SERVICE BULLETIN 38

SUBJECT: LOCATION OF FLAP CONTROL ASSEMBLY

APPLICATION: All Glasair III aircraft, all Glasair II TD, and FT Aircraft.

FIGURE (A)

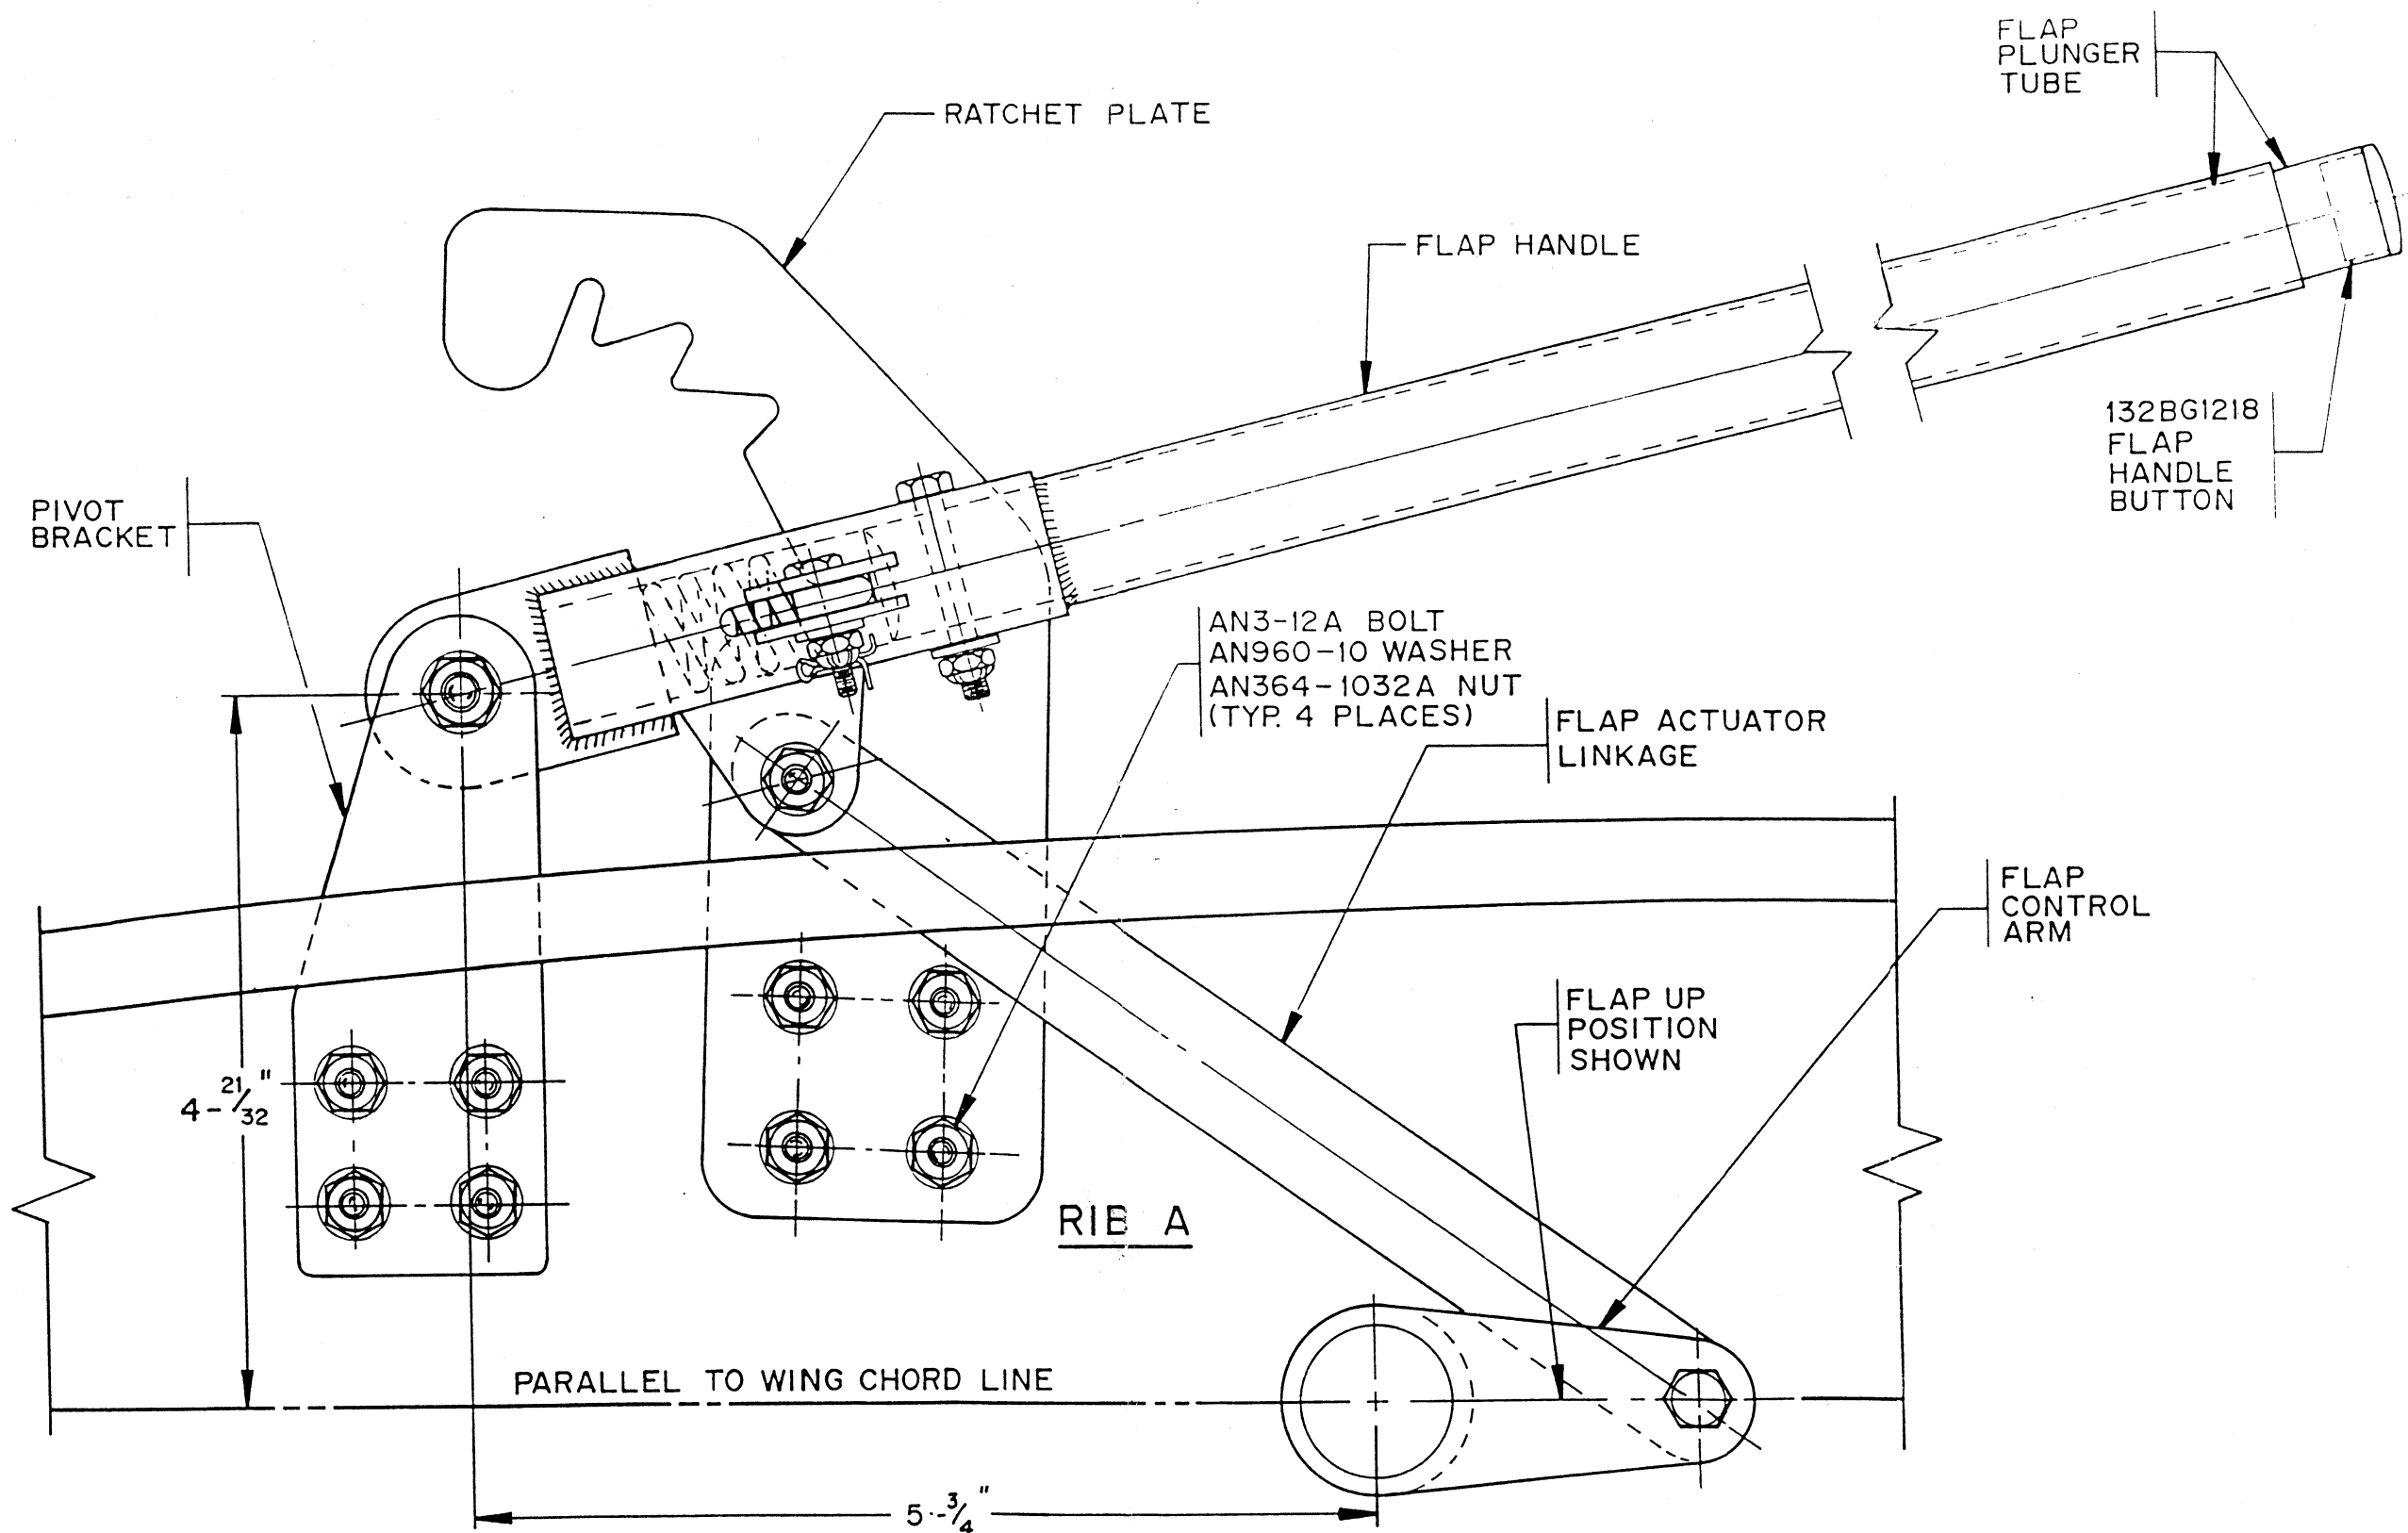
Description: The locating dimensions shown for the Flap Actuating Mechanism in the Manual References listed above, are incorrect. The proper locating dimensions are shown in the enclosed FIGURE (A). The correct dimensions have been incorporated in the Glasair II RG Assembly Manual and will be incorporated in the next revision for the remaining manuals.
